RE: S4.55(2) MODIFICATION APPLICATION TO SSD 7387 IN RELATION TO CAMDEN MEDICAL CAMPUS, GLEDSWOOD HILLS

This Statement has been prepared for Gregory Hills Development Company Pty Ltd (GHCP) by City Plan Strategy & Development Pty Ltd (City Plan) to accompany an application under Section 4.55(2) of the Environmental Planning and Assessment Act 1979 (the Act).

2.1. Overview of the Modifications

Figure 4: Elevation and Section Comparisons (Source: HPI)

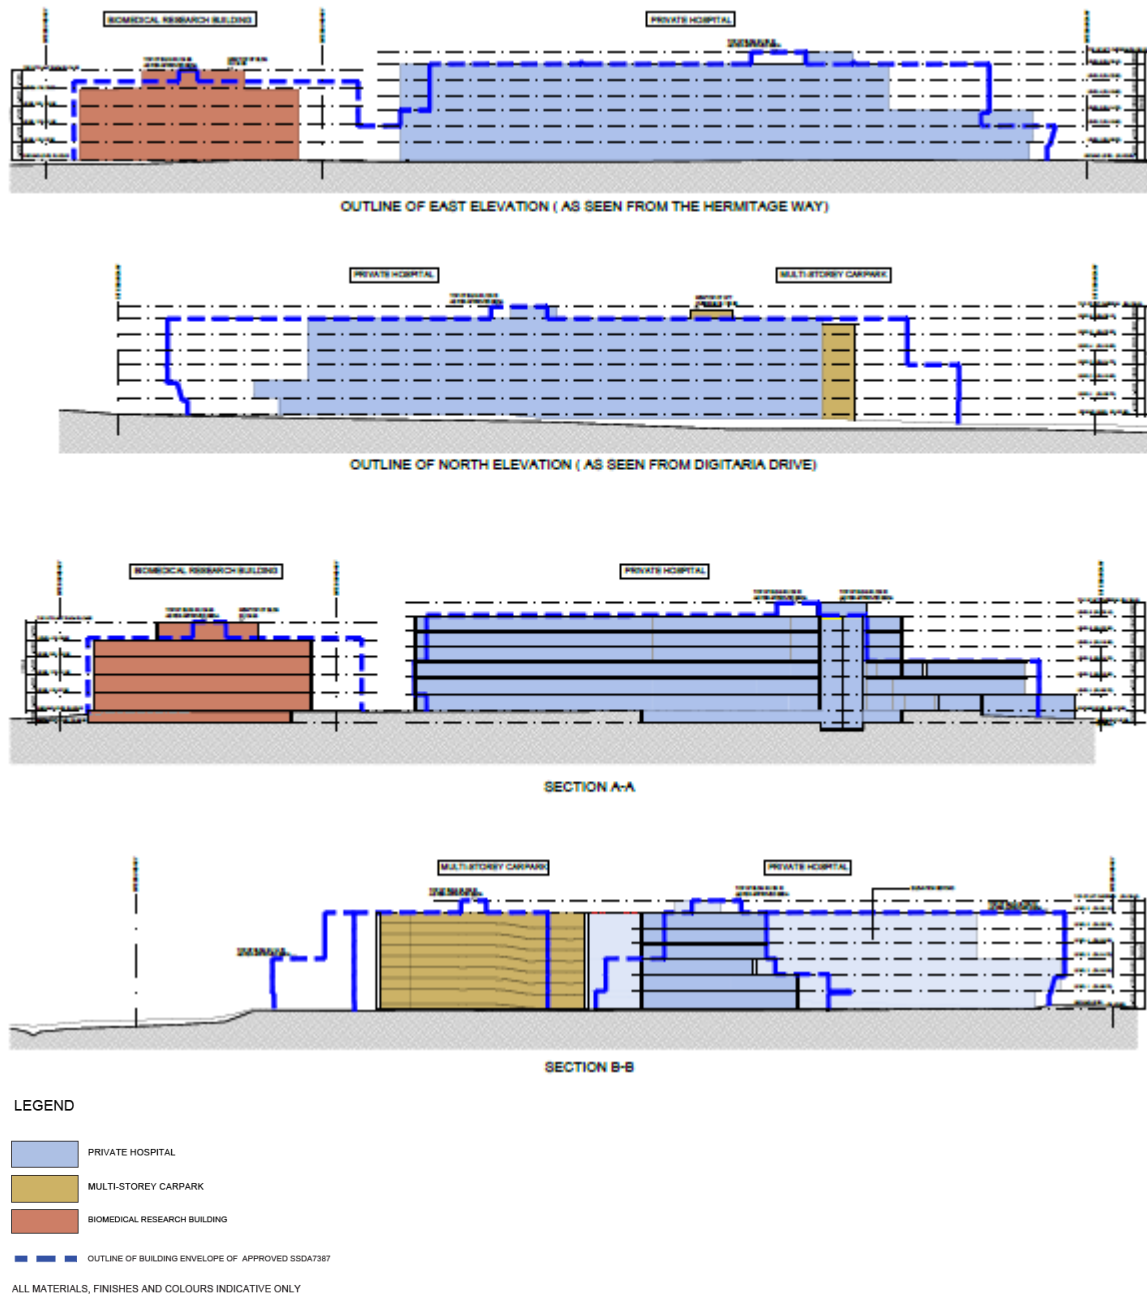
Table 2 outlines the development statistics of the approved development when compared to the modified development. The modifications result in a reduction of approximately 9,312m² of GFA across the site. At ground floor level, the building footprint is reduced by 3,727m² (refer to the Architectural Design Statement at Appendix 2 for further detail). There is no reduction to the maximum height of the hospital and multi-storey carpark, but a reduction in height of the biomedical research building.

Figure 4 illustrates a comparison of the proposed modifications to the built form, which has ultimately decreased the GFA of the approved built form.
